## Determination 2009/103

### The compliance of a roof to part of a new house at 28D Rata Street, Oxford, Waimakariri

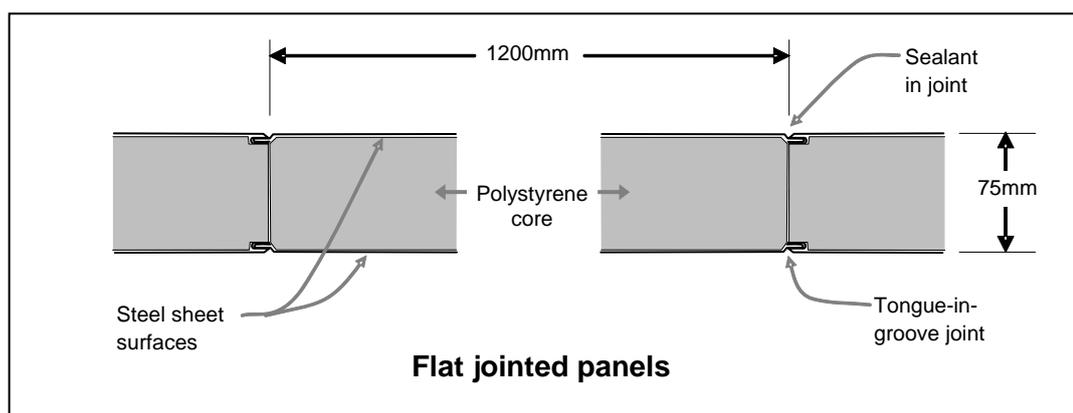
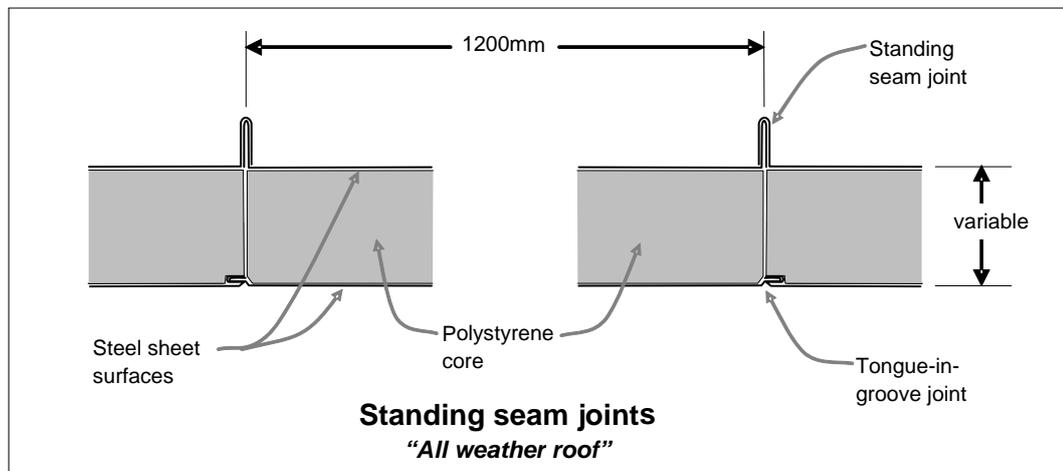
- 2.4.1 The roof is constructed using prefabricated panels, with the panel joints parallel to the fall of the roof. The consent drawings show the roof at a minimum pitch of  $1.5^\circ$ , with a gutter at the northwest end and the junction between the end of the roof and the gutter covered by a metal “Z” flashing.
- 2.4.2 The roof panels are 1200mm wide and 75mm thick; and incorporate a polystyrene core sandwiched between pre-finished flat steel sheets as shown below:

- 2.4.3 The edges of the steel outer faces are folded to incorporate a tongue-in-groove joint system. Sealant used on the exterior results in the joints sitting slightly proud of the roof surface.
- 2.4.4 I note that the consent drawings do not specify the particular roof panel system used; and from the manufacturer’s descriptions of its products it appears that the flat-jointed system is intended for use as wall cladding. The systems described by the

manufacturer as ‘roofing’ include the product described as an ‘all weather roof’ (shown below). The all weather roofing panel incorporates a vertical mechanical seal and the manufacturer recommends a minimum roof pitch of 4°.

- 7.2.2 The manufacturer of the roof panels recommends a minimum pitch of 4o minimum for the all weather roof standing seam panels, and it is not clear whether the manufacturer recommends the flat-jointed roof panel system for particular situations such as this conservatory roof
